WPCA AGENDA - Revised 04/22/2021

Thursday, April 29,2021 – 6:00 PM Virtual Meeting Via Zoom

TO:	Water Pollution Control Authority	DATE:	4/21/2021
FROM:	Dennis Dievert Jr.	PROJECT NO.:	20458
SUBJECT:	Sewer Feasibility Approval 181 West Johnson Avenue

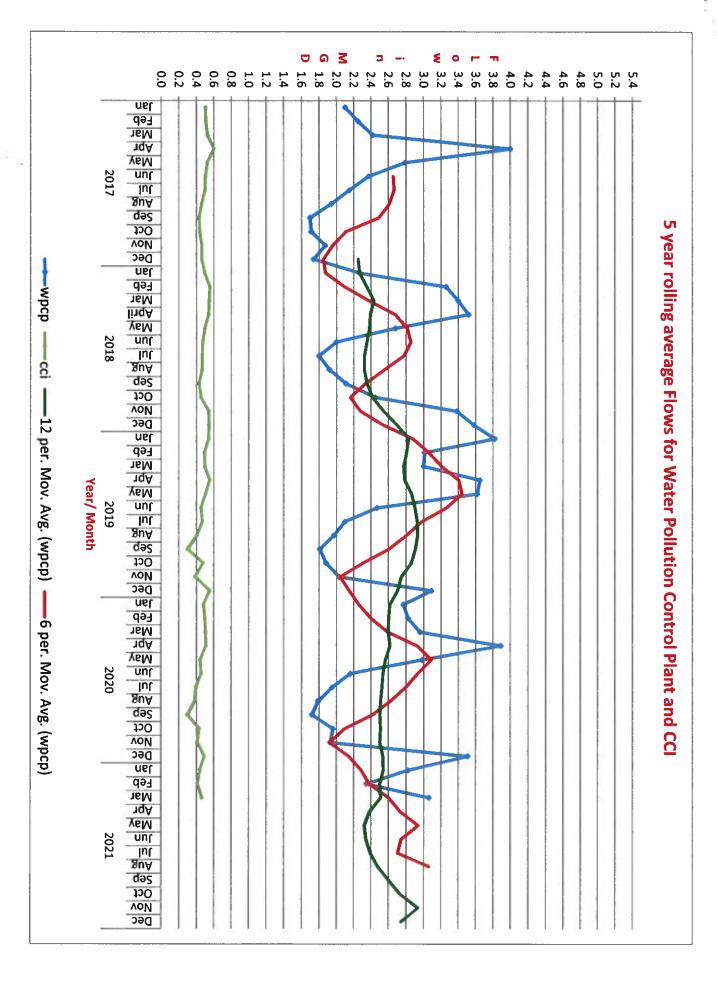
This application is for a 243,932 square foot addition to an existing 485,600 square foot warehouse facility. The area is depicted on the Town's Map of "Unsewered Properties in C&D Conservation Areas and Sewer Recommendations" as being in a Sewered Area. The existing warehouse is connected to an 8" sewer that increases to a 10" sewer before discharging to the exiting sewer main on West Johnson Avenue upstream of the West Johnson Avenue Sewer pump Station. Projected increase in flows of 300 gallons per day flows are reasonable for the anticipated use. The project proposes the installation of approximately 100-feet of new 8" PVC sewer and one new sewer manhole from the warehouse addition to an existing manhole on the project site before being conveyed to West Johnson Avenue. The project is proposed in two phases and anticipated to be occupied in the fourth quarter of 2022.

The layout of the sewer and provided details are acceptable. It is assumed that there is no proposed increase in water meter size for the project based on the submitted plans. I reached out to the applicant who stated there are no plans to increase the meter size but that they do not yet have a tenant. Therefore, this should be confirmed by the applicant prior to approval. In addition, any floor drains from the addition should be discharged to an oil/water separator.

If the water meter is not being increased in size, the project does not need to pay any capacity fees for the new addition since the existing facility is currently connected to the sewer system and the water meter size is not being increased as outlined in the WPCA Sewer Regulations. If the water meter size is being increased, and sizing provided, then the Capacity Fee shall be based on the difference in meter size and calculated per the Capacity Fee Schedule in the WPCA Sewer Regulations. The method of annual sewer fees for the new addition will be based on the town's currently adopted commercial rate structure.

Subject to the issues addressed above, the project is recommended for feasibility approval.
